Service Bulletin

RRP Service Bulletin No: RRP SB358

Title: Mounting Plate Kit for ATPI Center Jack Latch

Product Series: Advanced Tie Plate Inserter [ATPI]

KIT, MOUNTING PLATE / RRP# 793089 [Rev 3 (2.2021)]

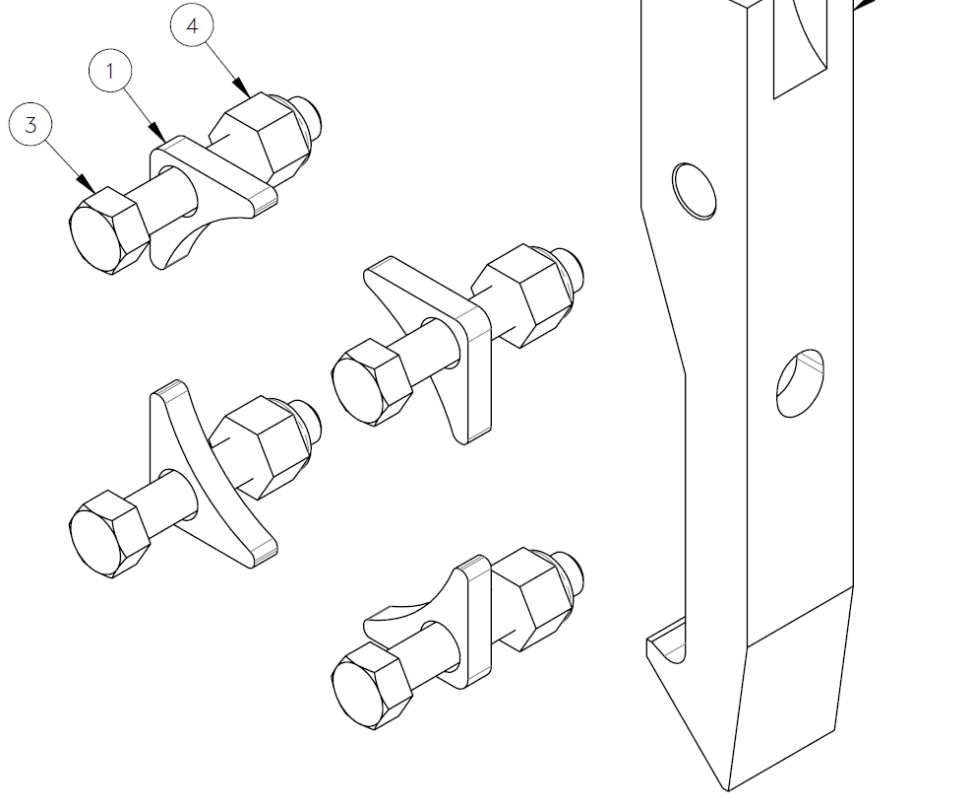
Summary: The center jack foot does not lower enough.

1. Adjust the machine workhead to Maintenance Mode.
2. Unlock and lower the center jack.
3. Remove split collar 472288 (see Detail B).
4. Remove the center jack cylinder four bolt assemblies (see Detail B).
5. Replace bolt and spacer assemblies with kit supplied spacers and fasteners. Items 1, 3 & 4 (see Detail B).
6. Replace existing latch with new latch 322179 (supplied).

Continue with normal machine operation after installing the center jack mounting plate spacers.
